**ADDENDUM NO. 2**  
**LUCCHESI TURF FIELD REPLACEMENT**

**C14502008**

**July 18, 2025**

This Addendum No. 2 modifies the bidding documents for the **LUCCHESI TURF FIELD REPLACEMENT** Project. This Addendum shall become part of the Contract and all provisions of the Contract shall apply thereto. Bidders shall acknowledge all Addendums in the Bid Schedule.

DRAWN BY	CHECKED BY
KL	WD/DC
DATE ISSUED	SCALE
06/13/25	1"=20'-0"
PROJ. NO.	
	2108300
SHEET NO.	
	L3.0

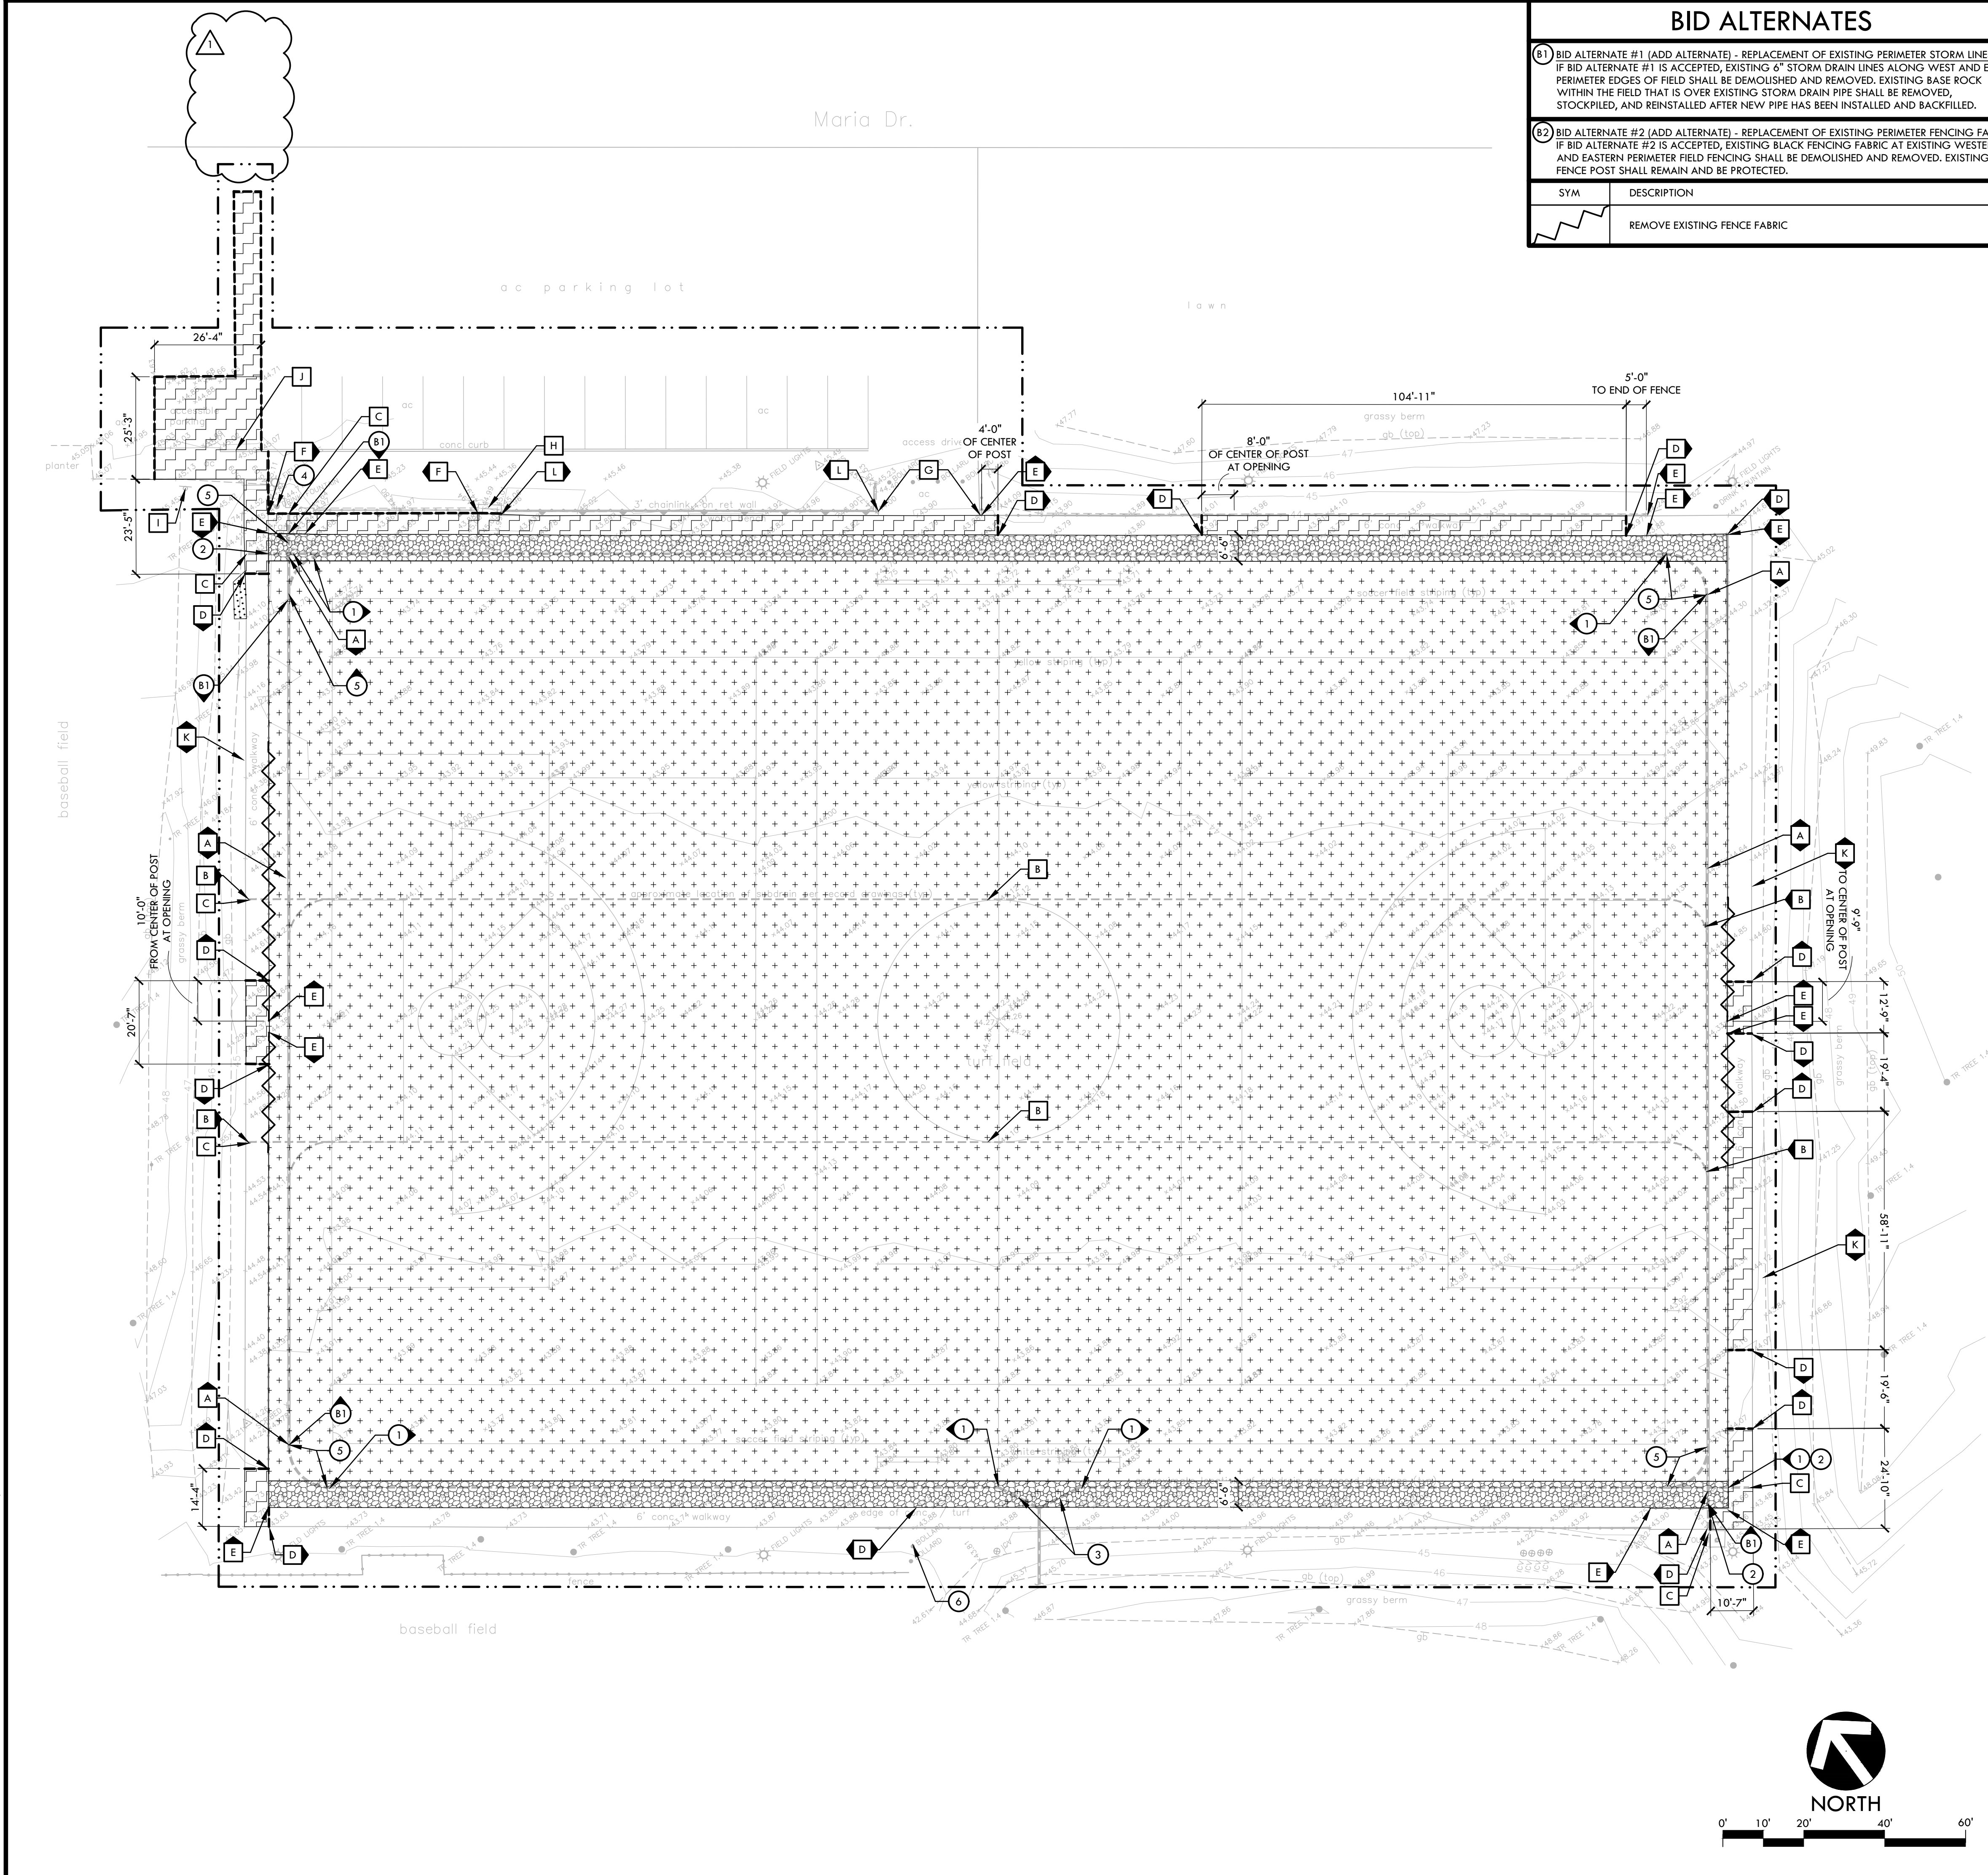
**2. Demo Sheet L3.0 show to, "Remove existing permeable rock base, subdrain rock and existing pipe, and replace with new per Detail A, Sheet LD1.0 and Sheet L5.0. Can you confirm the existing inverts match the proposed and that the existing trench prism should theoretically match existing?"**

Response: New pipe inverts will be as shown on L5.0. The new pipe for the base bid work will connect into a new Junction box as shown on L5.0. Existing pipe that is to remain (unless replaced as part of the bid alternate) will not have their inverts modified and shall be connected to the new junctions.

MATERIAL AND  
DETAIL REFERENCE  
PLAN

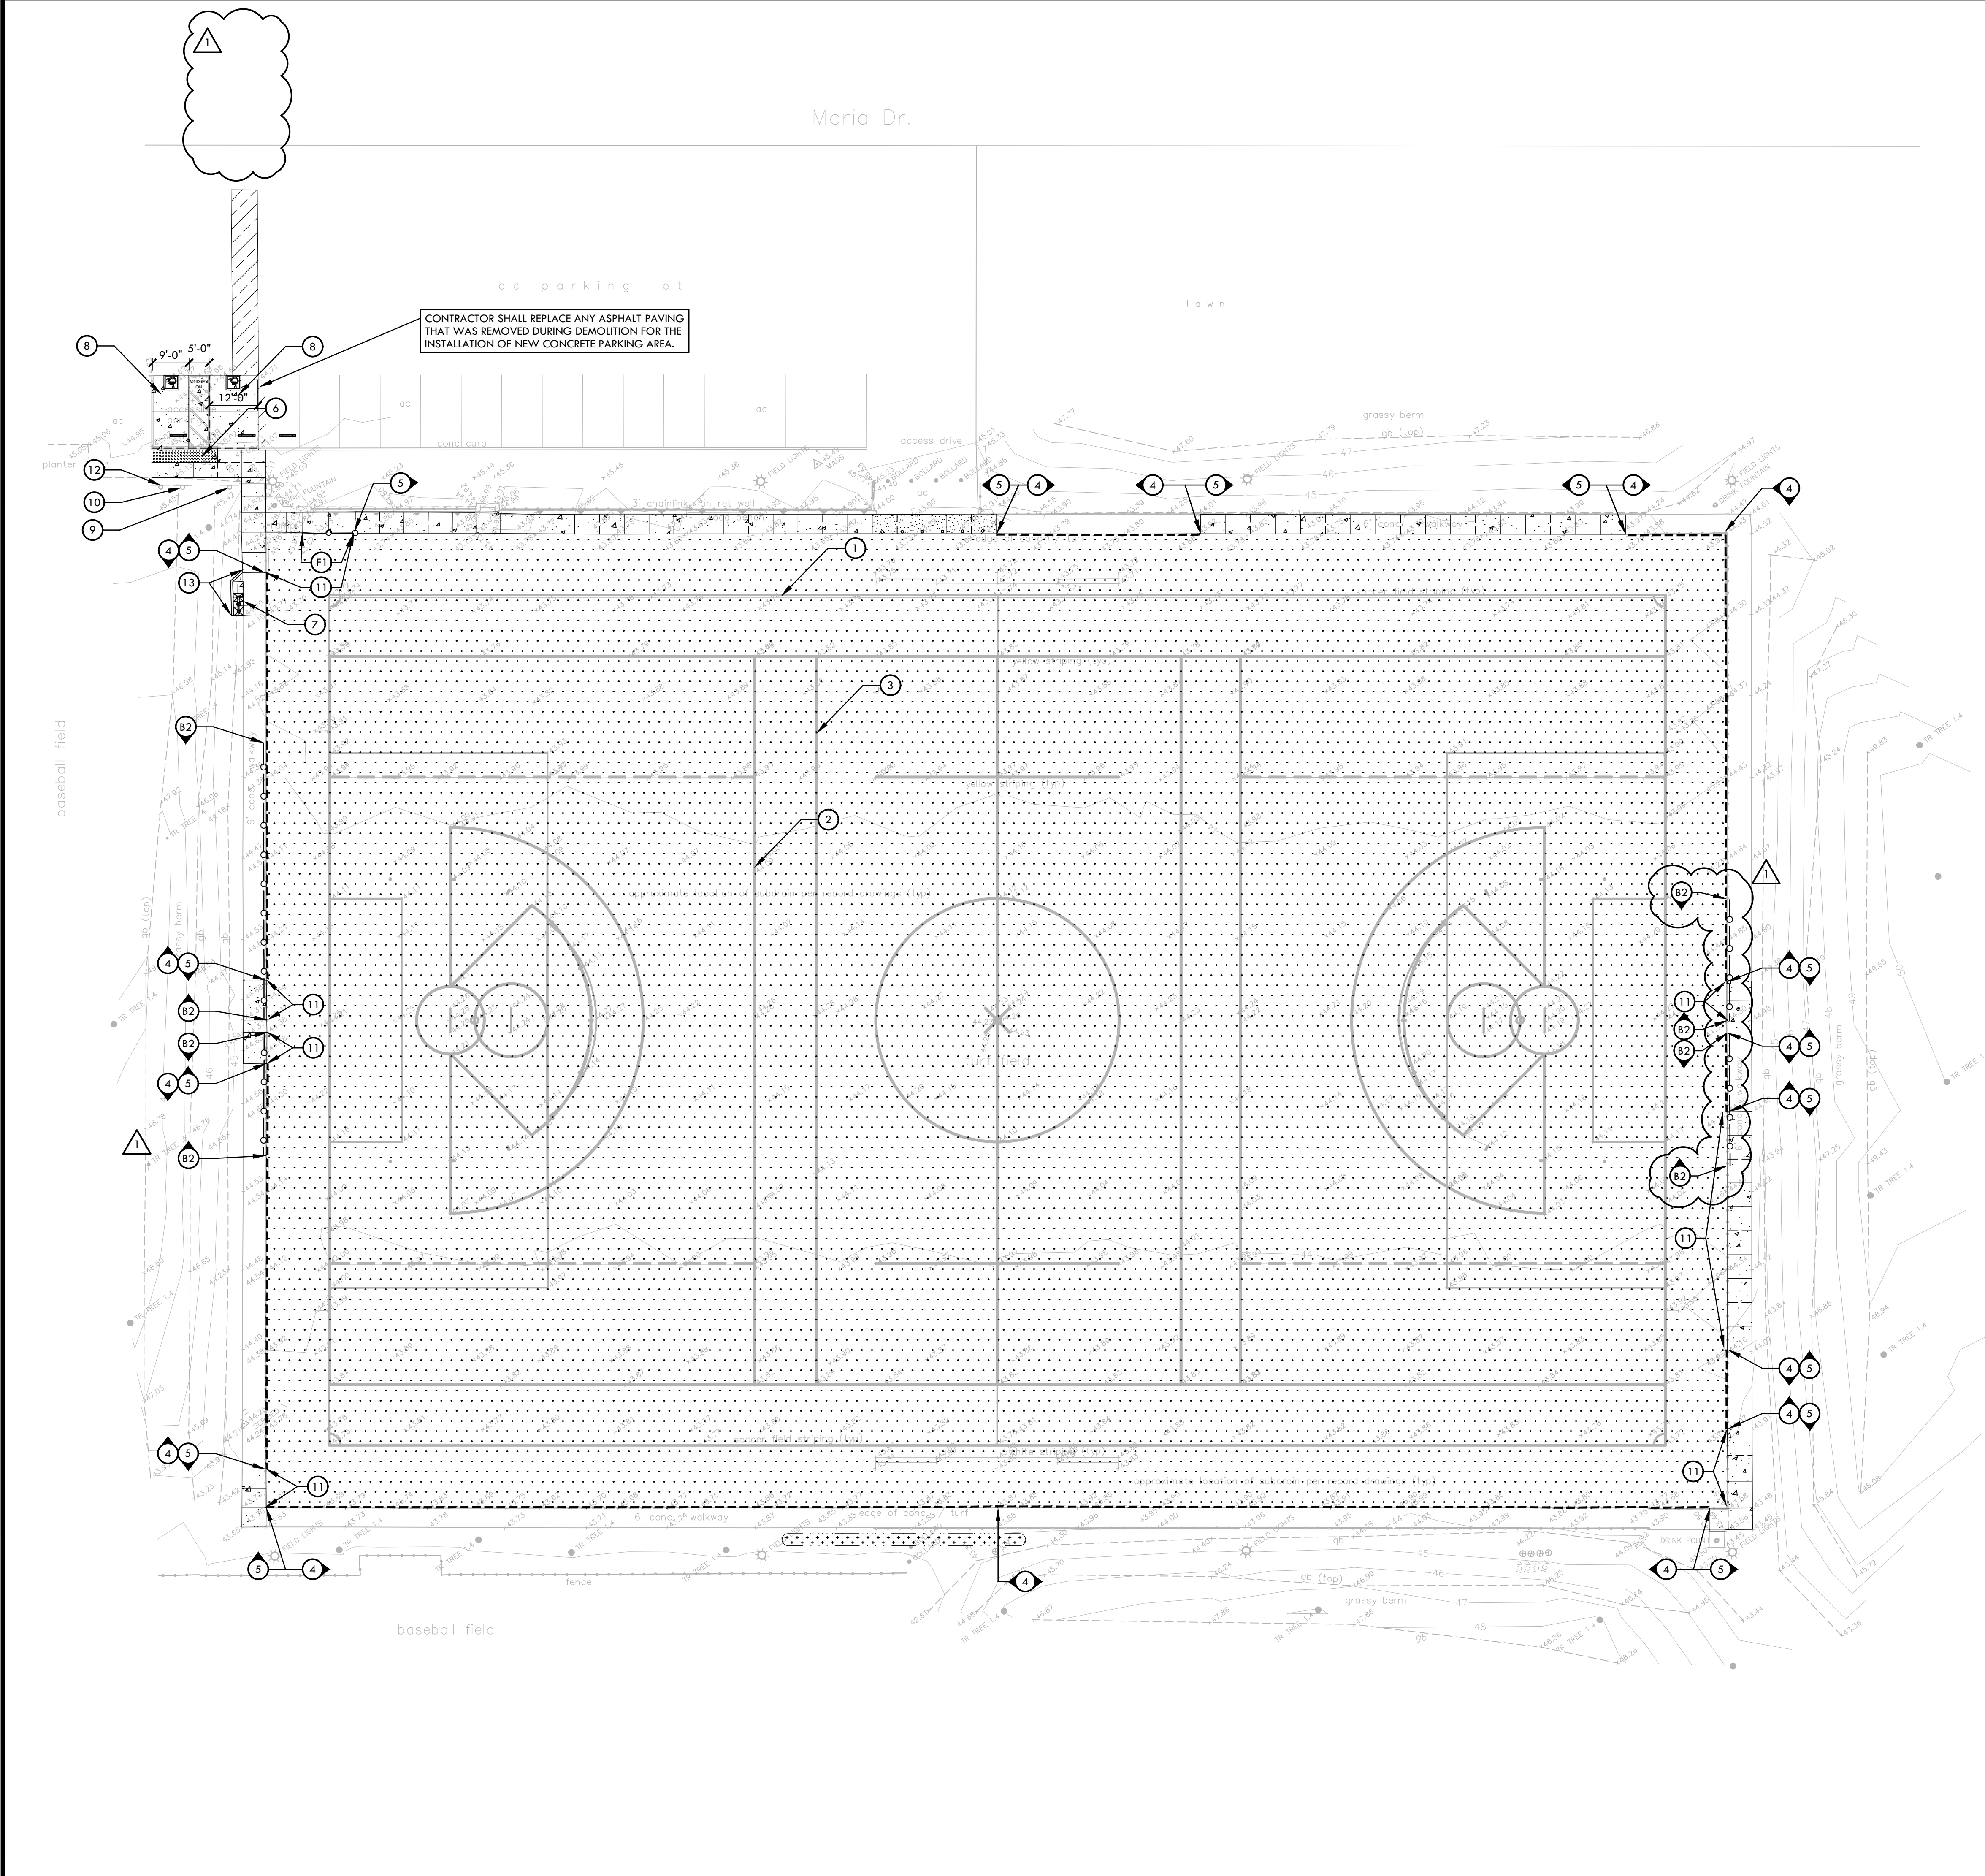
**18. Clarify the location of the thickened edge for the new concrete.**

Response: The thickened edge detail for the new concrete is applicable only at the locations identified as Item #11 in the Material Legend on Sheet L6.0. No other areas require a thickened edge unless explicitly noted. The Bid Schedule quantity has been revised to 122 linear feet.
